# Modification Recommended Service Note

## 6675A DC power supply, 0-120 V, 0-18 A, 2160 W. GPIB

Serial Numbers: "MY53000140 to MY53000698 and SG53000101 to SG53000108"

The Problem – 6675A exhibited out of specification values for 48V to 52V at front panel read back readings.

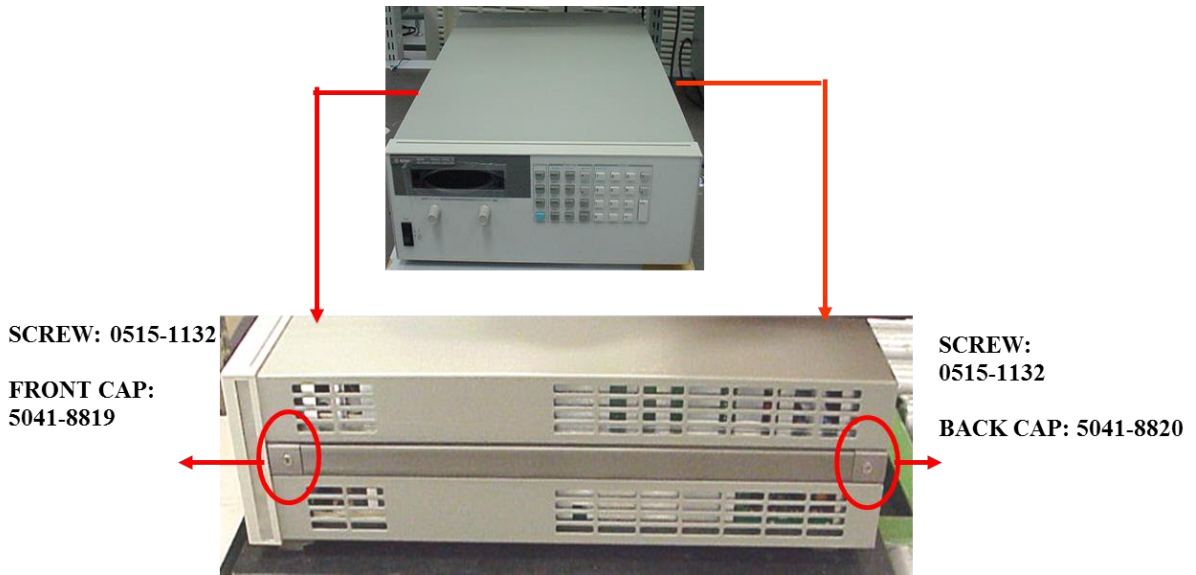
1. Set voltage to 51.1V and turn on the output. If the unit is good, the front panel will show voltage value (read back voltage) that is within the specification to 51.1V (+/-0.21V).

2. Any front panel voltage value reading out of 50.89V ~ 51.31V range is consider out of specification and need to send back to nearest SSU for PCA board replacement.

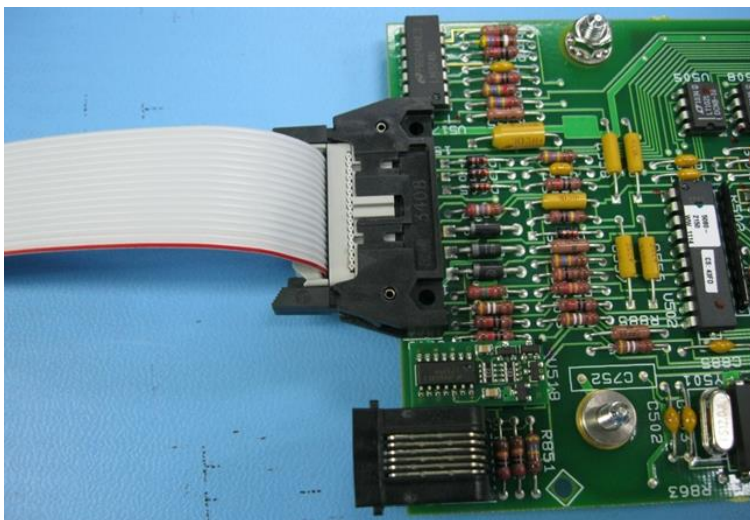
6. Replace with a new PCA board (06675-61020).
